We thank both reviewers for their constructive and insightful comments, which will help us to improve the manuscript. We address each reviewer comment below (in bold) and describe the revisions made to the paper where appropriate.

This paper has estimated methane emissions from offshore gas facilities in the Southern North Sea based on airborne observations of CH₄, CO₂, C₂H₆. A mass balance approach was applied to the observed CH₄ enhancements downwind of the targeted facilities to derive the emissions. Furthermore, the estimated emissions were compared to inventory studies, operator-based facility-level reporting, and other relevant and similar studies. Top-down quantification of CH₄ emissions from offshore oil and gas facilities is much needed to independently evaluate various CH₄ emissions, either expected or unexpected, and these efforts are very useful to help mitigate CH₄ emissions. The manuscript is well structured and well written, and will be suitable for publication after addressing my comments below.

Figure A2. Scatter plot for co-emitted CO_2 downwind of platform P1. CO_2 was enhanced for two peaks at altitudes above 240 m.

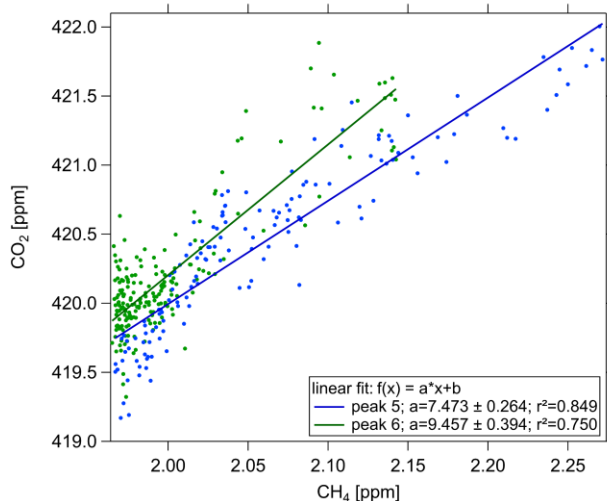
L329-330, Figure 3, it would be nice to see the scatter plots of CH_4 vs. CO_2 and CH_4 vs. C_2H_6 .

→ We agree. We added the scatter plots of CH_4 vs. CO_2 in the appendix (Figure A2 in Appendix A), since CH_4 and CO_2 were measured by the same instrument (Picarro Analyser). The slope of the linear regression of the scatter plot is taken for the estimation of the CO_2 flux given in Table D1 in Appendix D. We did not add the scatter plots of CH_4 vs C_2H_6 , because C_2H_6 was measured by another instrument (TILDAS, Aerodyne Research Inc.), which has a different time resolution and small time-shifts compared to the Picarro instrument. Further, for the calculation of the C_2H_6 to CH_4 ($C_2:C_1$) ratios we take the integrated plume area.

“Figure A2 in the Appendix A shows the CH_4 to CO_2 scatter plot for P1. The CO_2 flux is determined from the gradient of a linear regression between the CO_2 and CH_4 enhancements since both species are detected by the same instrument (Picarro Analyser).”
